Tentative Tract Map No. 072939
Conditional Use Permit No. 201400179
Oak Tree Permit No. 201400027
Environmental Assessment No. 201400125

SUBDIVISION COMMITTEE REPORT

TRACT MAP NO. 072939

TENTATIVE TRACT MAP NUMBER 072939

EXHIBIT A

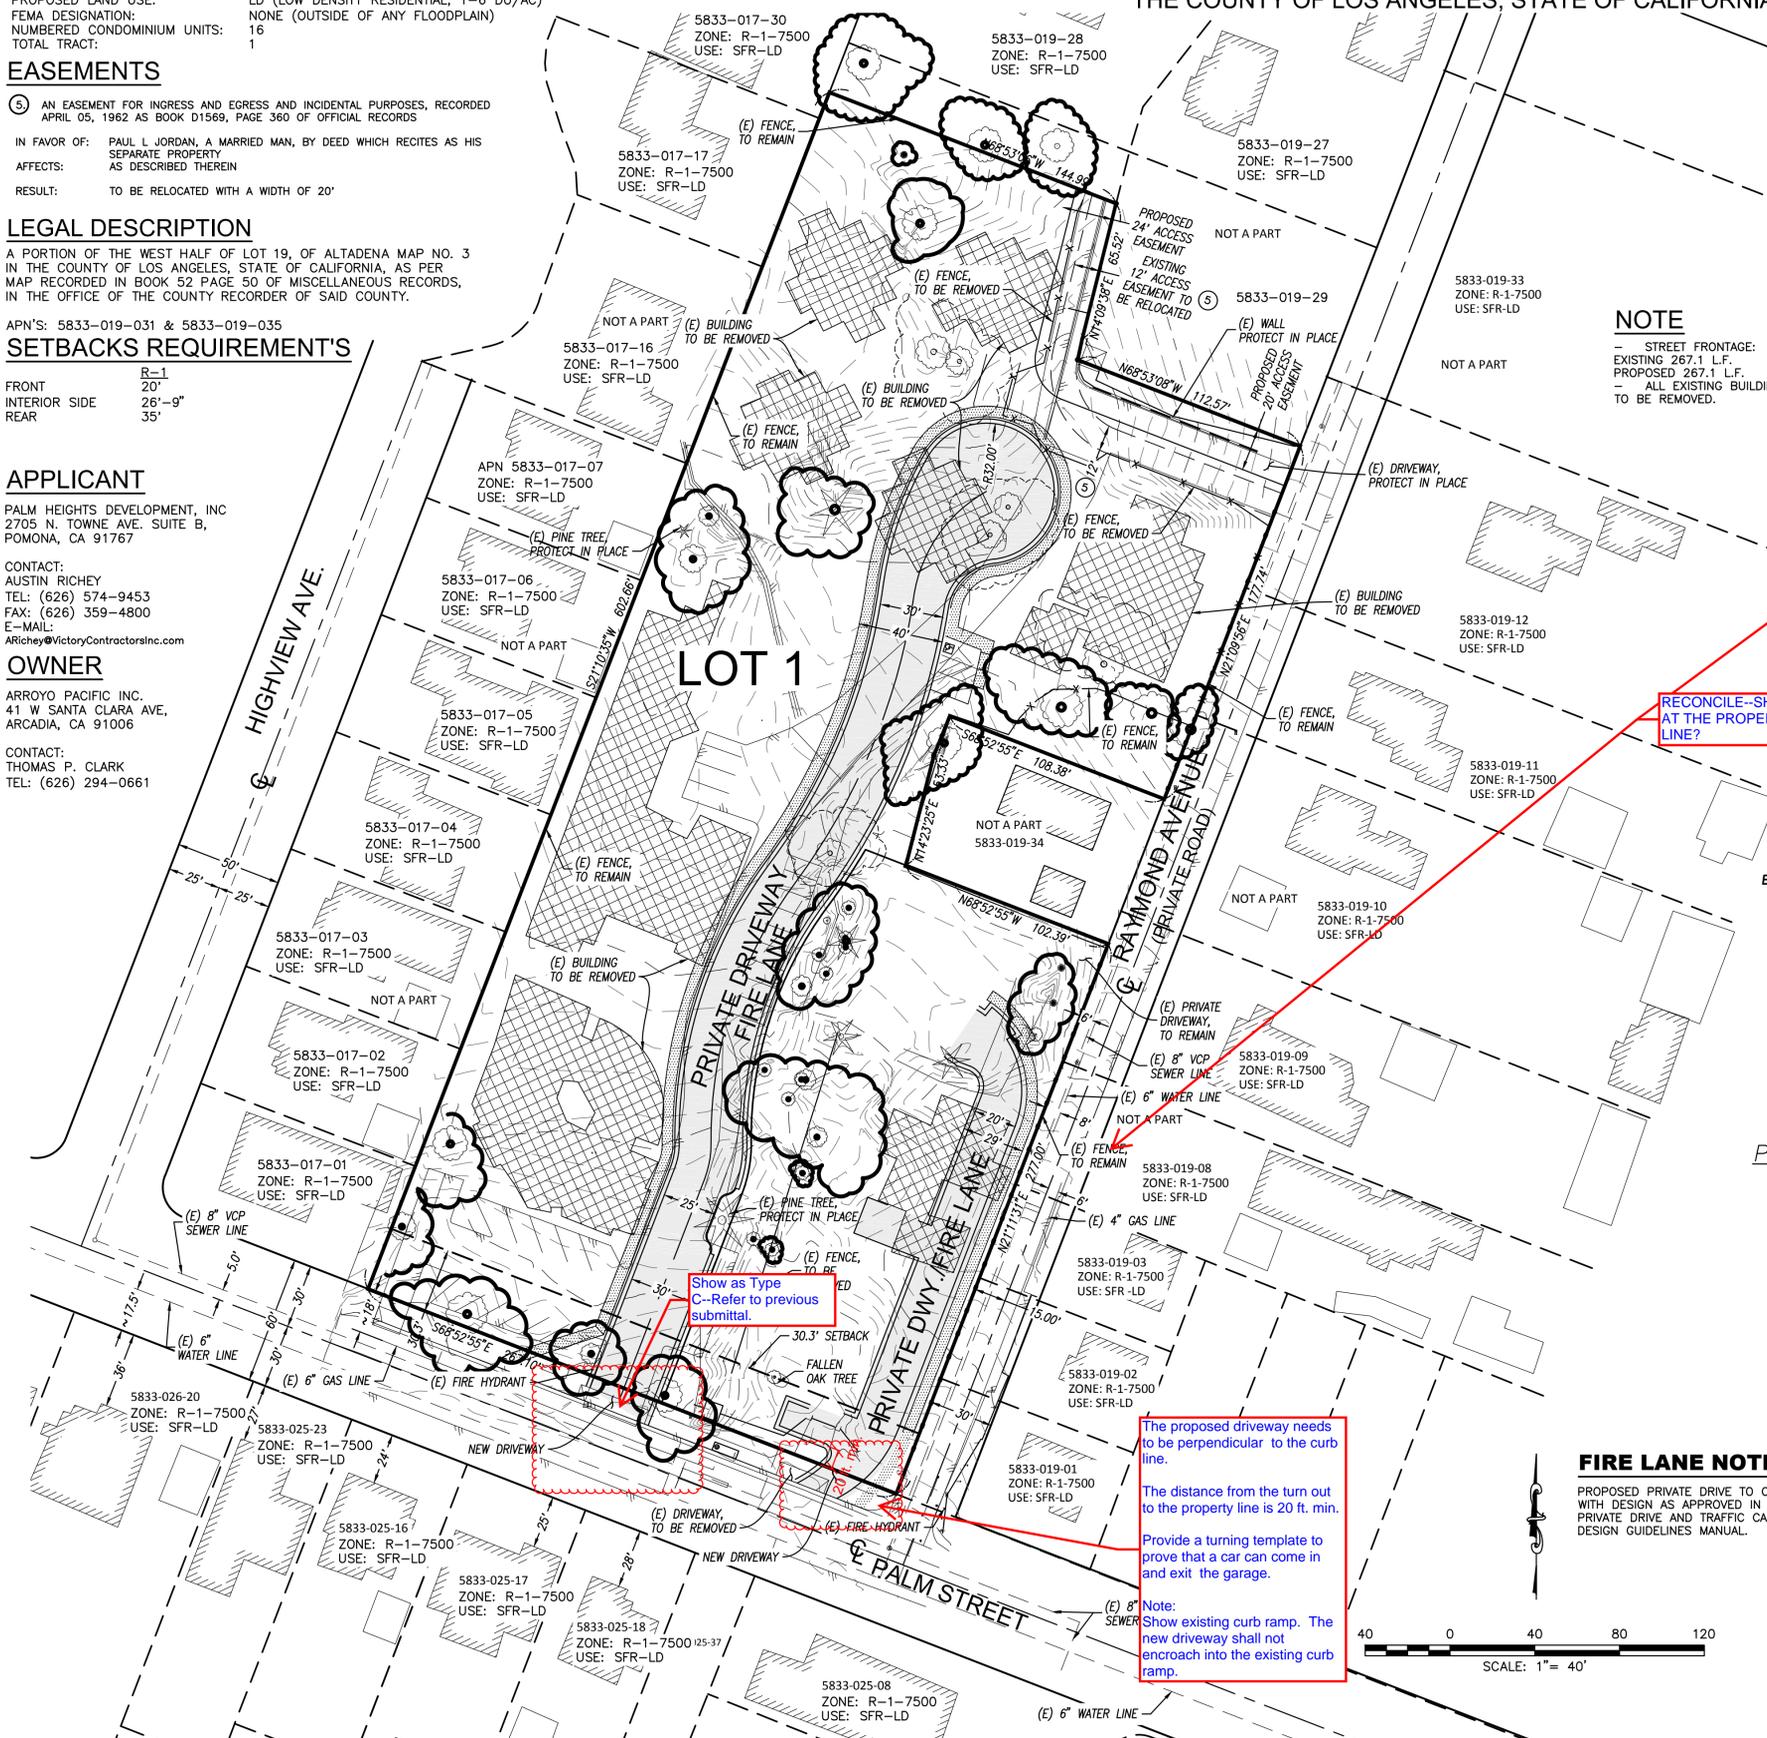
The proposed driveway needs to be perpendicular to the curb line.

The distance from the turn out to the property line is 20 ft. min.

Provide a turning template to prove that a car can come in and exit the garage.

Note: Show existing curb ramp. The new driveway shall not encroach into the existing curb ramp.

PRIVATE DRIVE AND FIRE LANE
1" = 10'

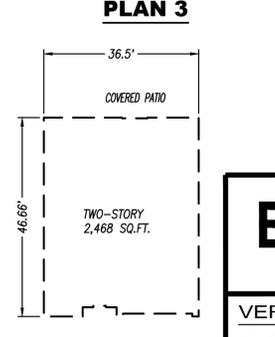
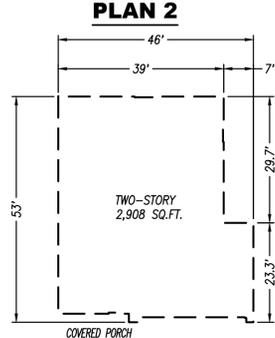
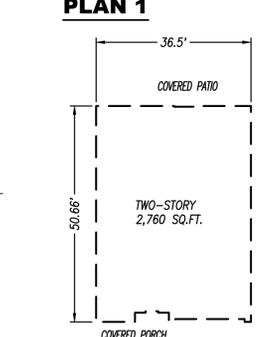
Tentative map and exhibit map need to show the same improvements except building foot-prints shown on exhibit map (TYP)
